## HISTORIC AND DESIGN REVIEW COMMISSION

**HDRC CASE NO:** 2018-352  
**ADDRESS:** 228 SHERMAN ST  
**LEGAL DESCRIPTION:** NCB 512 BLK 25 LOT W 58.33 FT OF E 116.66 FT OF N 48.7 FT OF 11  
**ZONING:** R-4, H  
**CITY COUNCIL DIST.:** 2  
**DISTRICT:** Dignowity Hill Historic District  
**APPLICANT:** Samuel Guerrero  
**OWNER:** Samuel Guerrero  
**TYPE OF WORK:** Front yard fence, detached carport  
**APPLICATION RECEIVED:** July 02, 2018  
**60-DAY REVIEW:** September 01, 2018  
**REQUEST:**

The applicant is requesting a Certificate of Appropriateness for approval to:

1. Install front yard cattle panel fence, not including a front yard driveway gate
2. Install rear carport

# Proposal for Fence

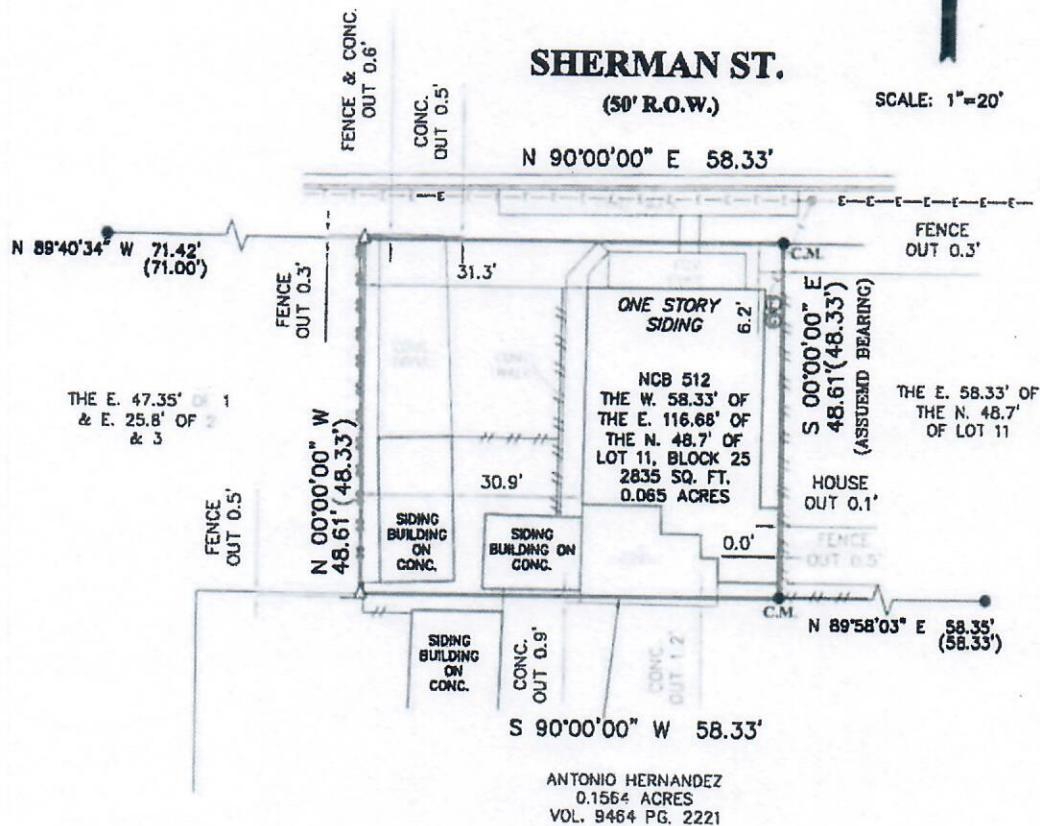
- b. FENCE LOCATION – The applicant has proposed to install a front yard cattle panel fence across the front yard and turning at the driveway to meet at the rear accessory structure, instead of spanning a gate across the driveway. Elements 2.B.ii, new front yard fences should not be introduced within historic districts that did not historically. Staff finds that fences are found on Sherman and within the Dignowity Hill Historic District. Staff finds the proposed location and configuration of the new fence appropriate.

- a. FENCE DESIGN - According to the Guidelines for Site Elements 2.B.i., the design of the fence should respond to the design and materials of the primary historic structure or structures of a similar style in the neighborhood in relation to scale, transparency, and character. Staff finds that the proposed cattle panel fencing is found within the Dignowity Hill Historic District and relates to the architectural features of the structure.

- i. Staff recommends approval of the front yard cattle panel with the stipulations that no portion exceeds 4ft in height and that the fence turns at the driveway to end in the rear yard, instead of spanning a gate across the driveway.
- ii. Staff recommends approval of the detached carport with the stipulation that a front facing gabled roof with matching roofing material be installed instead of the proposed low slope roof. The applicant is furthermore responsible for complying with any building setback requirements for the carport
